## **NOTICE OF PUBLIC MEETING**

**Governmental Body: Van Meter Planning and Zoning Commission**

VAN METER, IOWA  
GRAND RIDGE ESTATES TOWNHOMES  
PRELIMINARY PLAT/SITE PLAN  
REVIEW COMMENTS

**RE: Grand Ridge Estates Townhomes Plat 1 – Preliminary Plat / Site Plan**

**SANITARY SEWER PLAN & PROFILE**

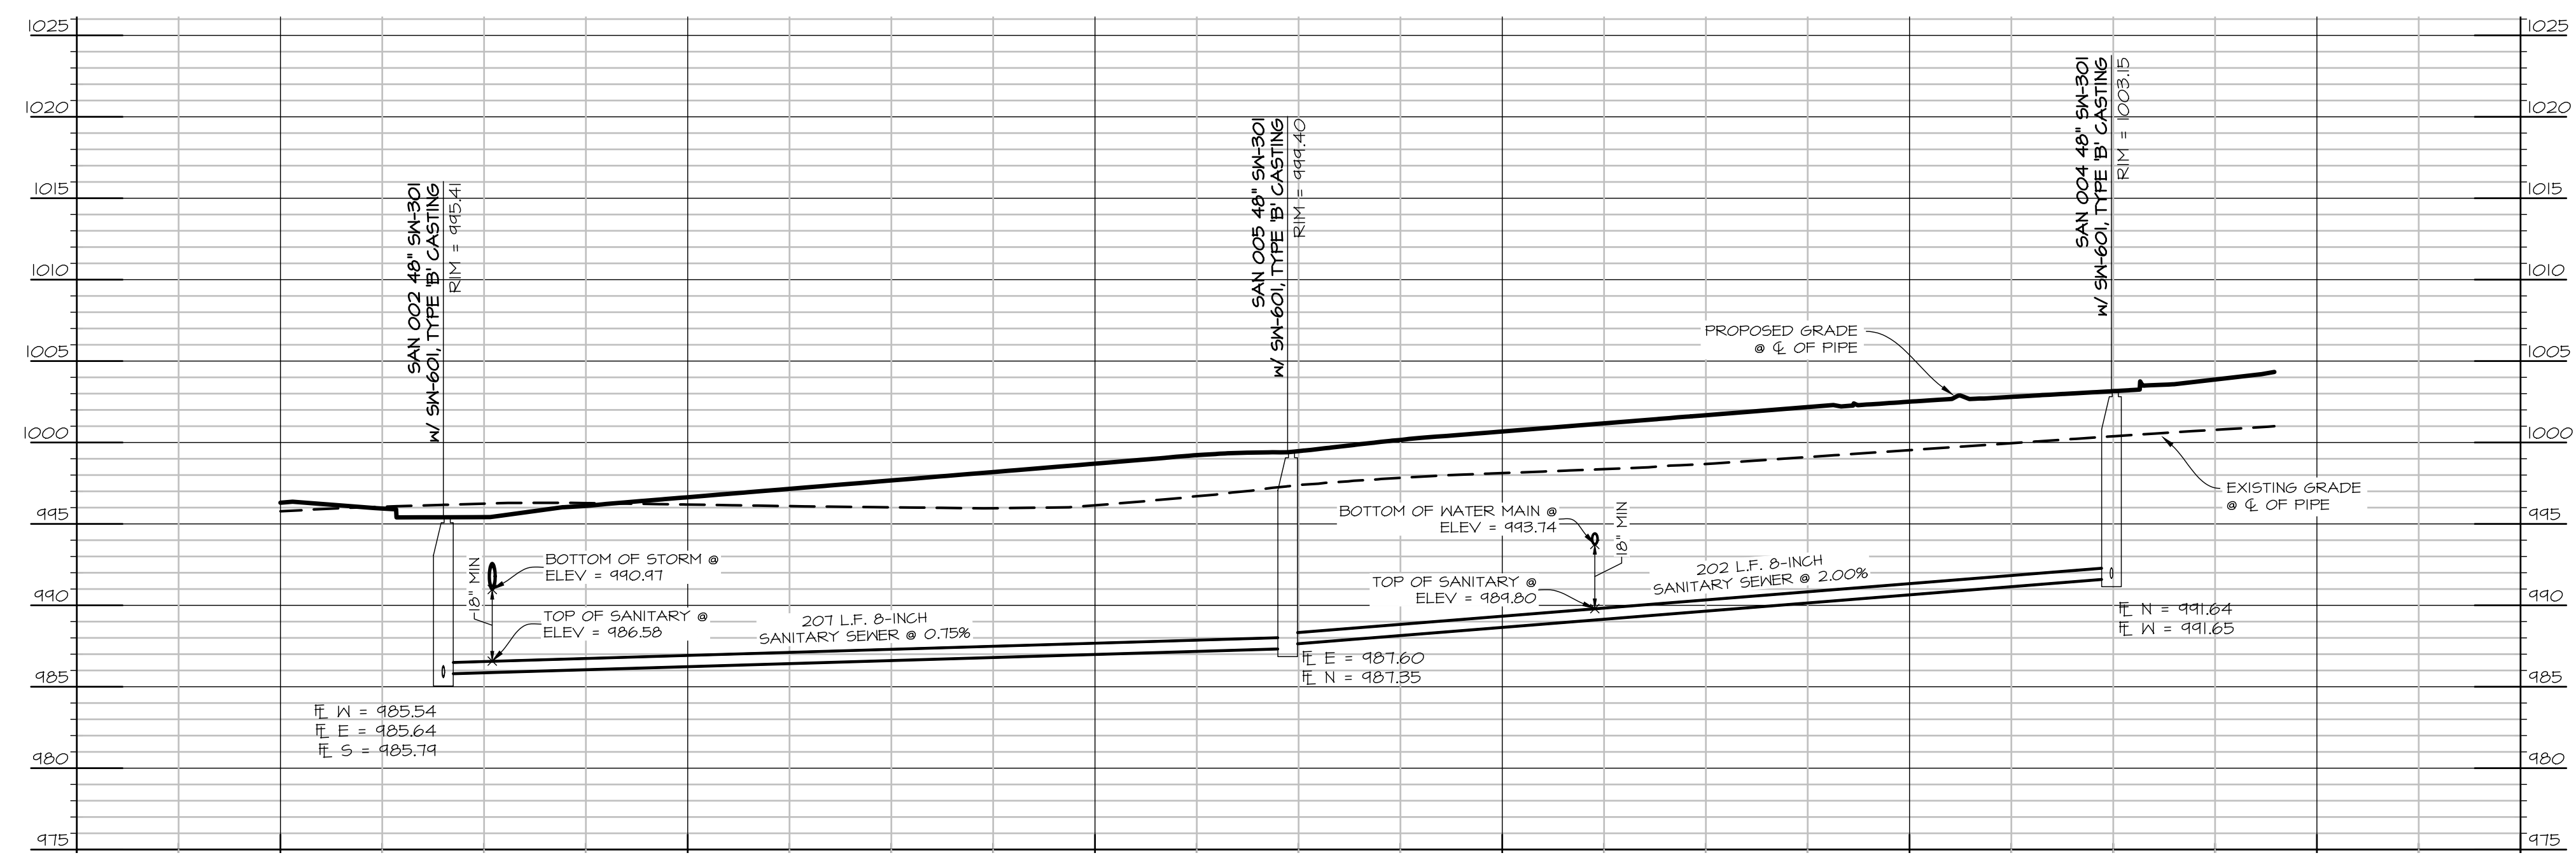
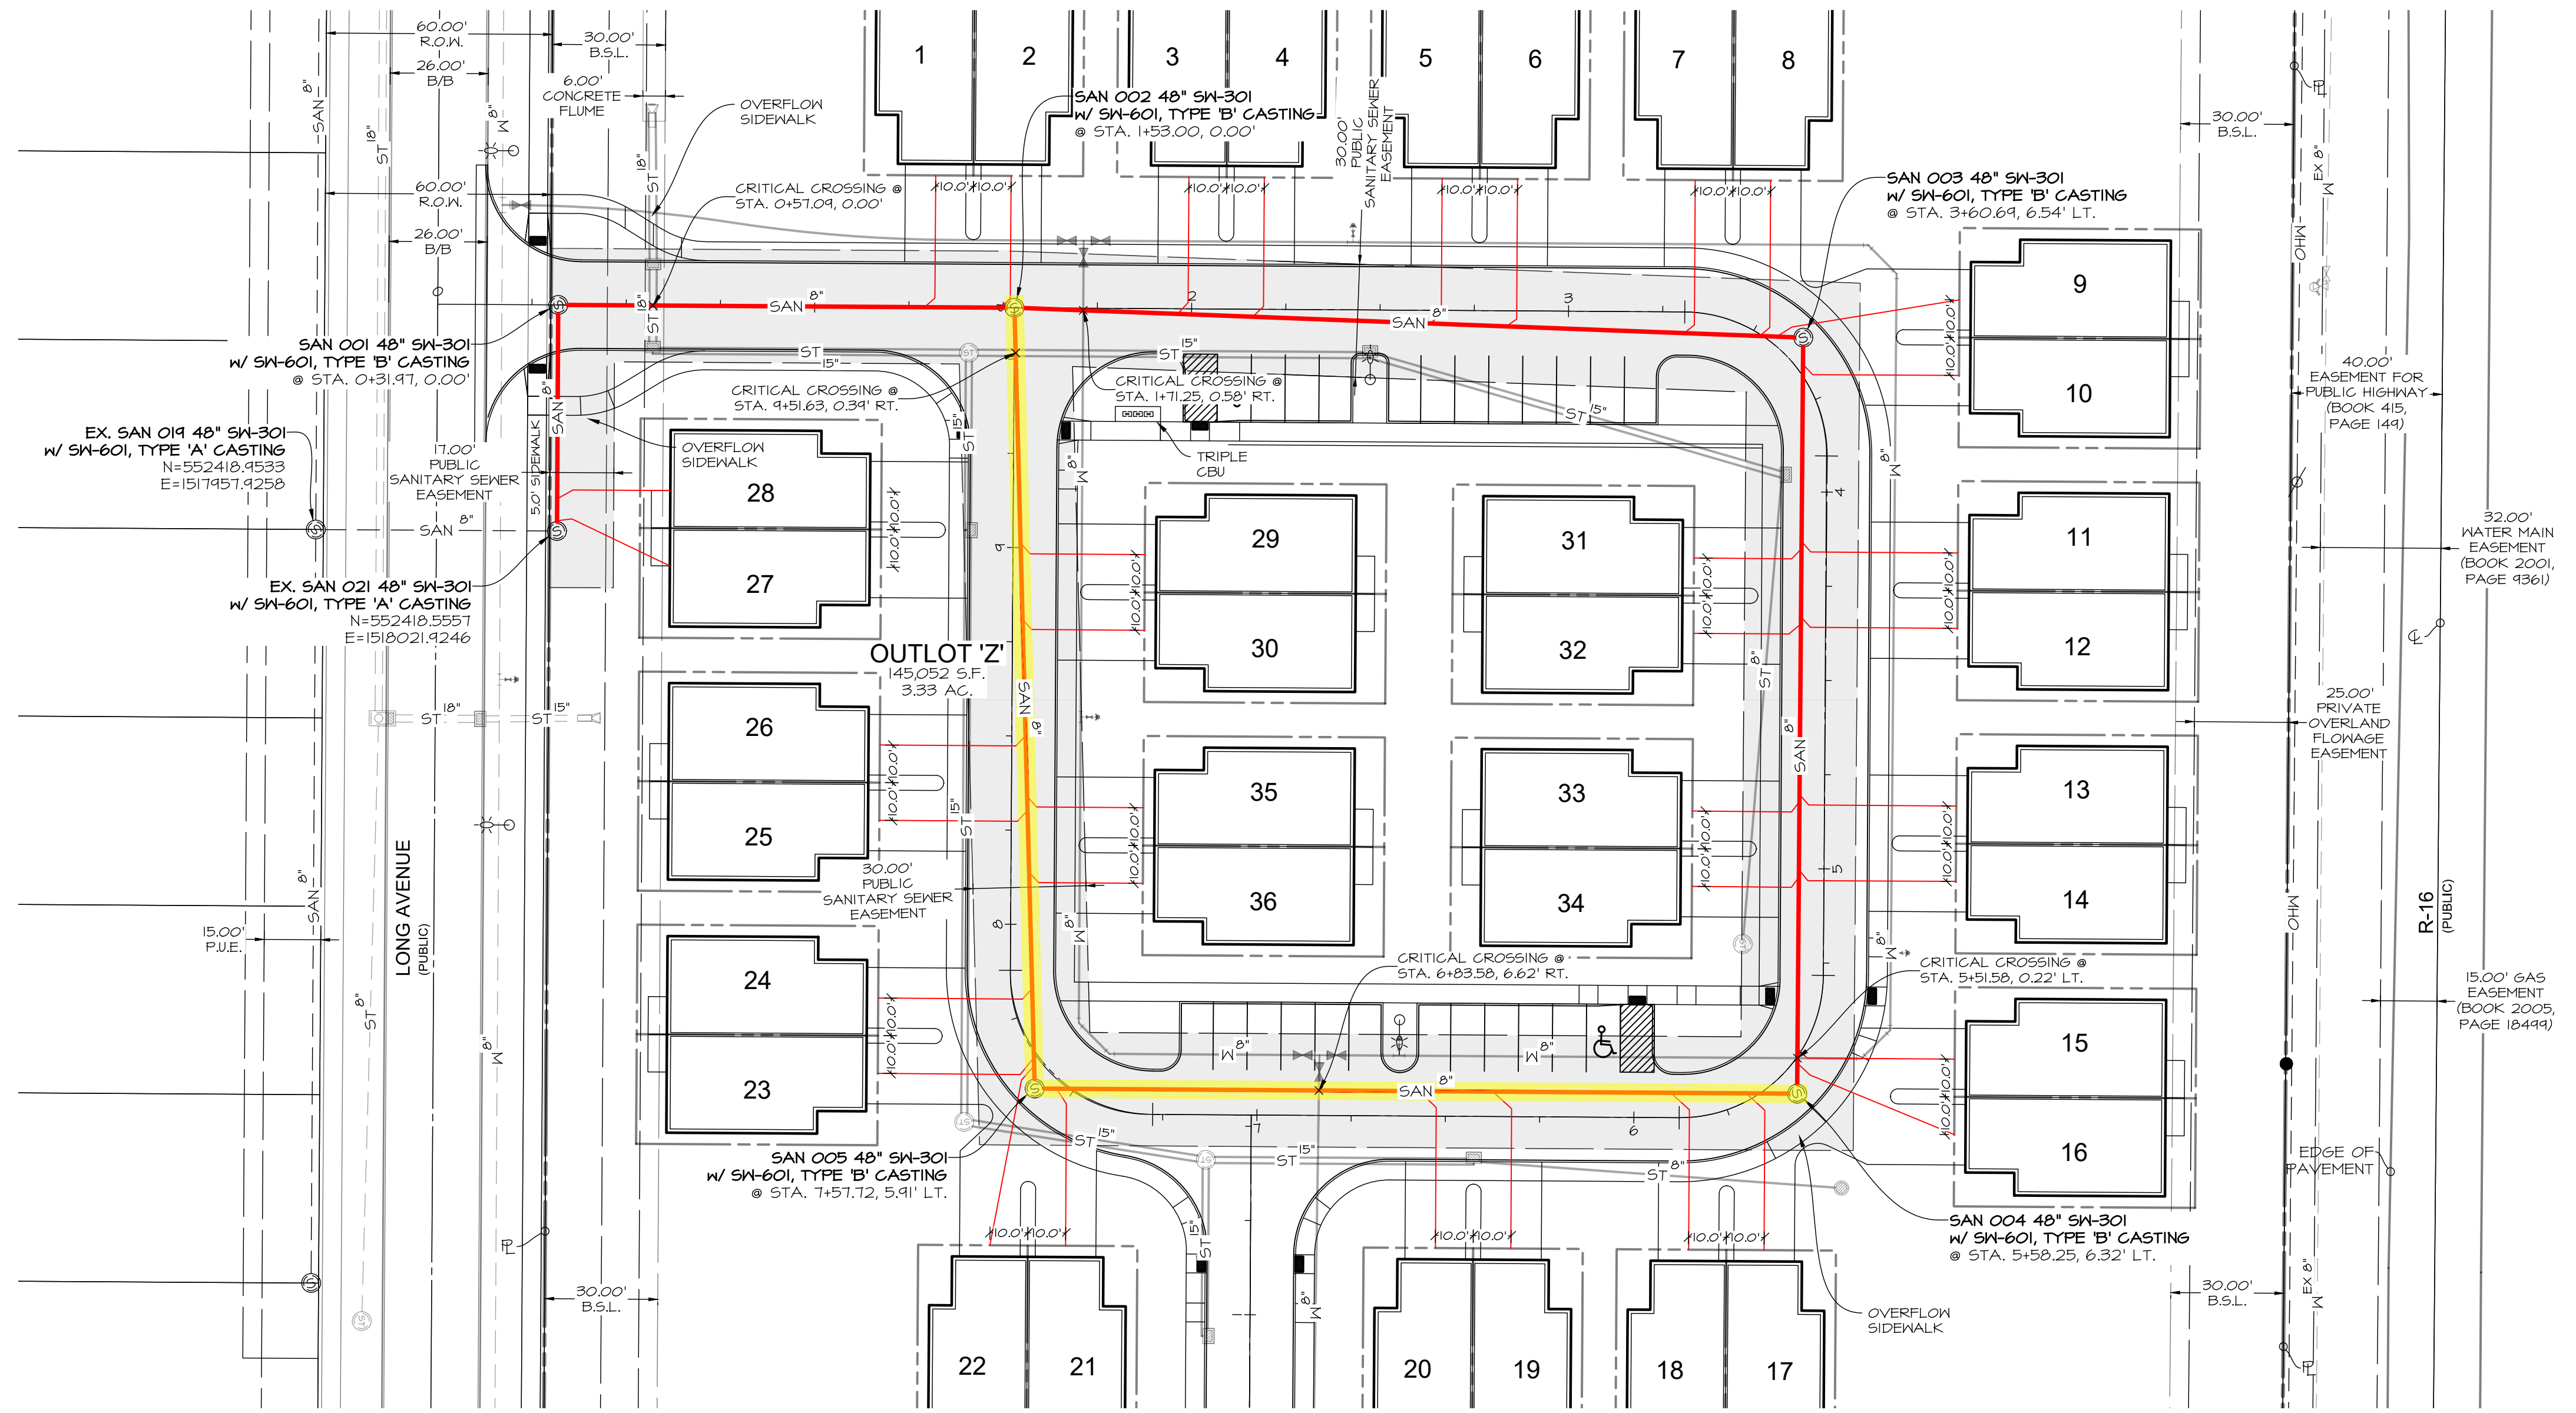
17. The sanitary sewers around the loop street are shown as 6-inch at a slope of 1.5% to 1.57%.

18. The preliminary plat indicates the intent for the sanitary sewer to be public.
19. Historically the City has required public sewers to be 8-inch diameter. The City will need to decide if it will accept public 6-inch diameter sewers, if it will require the 6-inch sewer to be private or increased in size to 8-inch diameter to be a public sewer.

14. The revised submittal includes additional information indicating the sidewalk ramps appear to be designed in compliance with ADA.
19. All of the 6-inch sanitary sewers have been increased in size to 8-inch diameter. With the 8-inch diameter size the sanitary sewers would meet the minimum requirement of the City for a public sewer.
28. The valve on the tapping sleeve and valve connection on Long Avenue is clarified to be outside of the pavement. The location is satisfactory.

19. Historically the City has required public sewers to be 8-inch diameter. The City will need to decide if it will accept public 6-inch diameter sewers, if it will require the 6-inch sewer to be private or increased in size to 8-inch diameter to be a public sewer. **The sanitary sewers have been revised to be 8-inch diameter.**
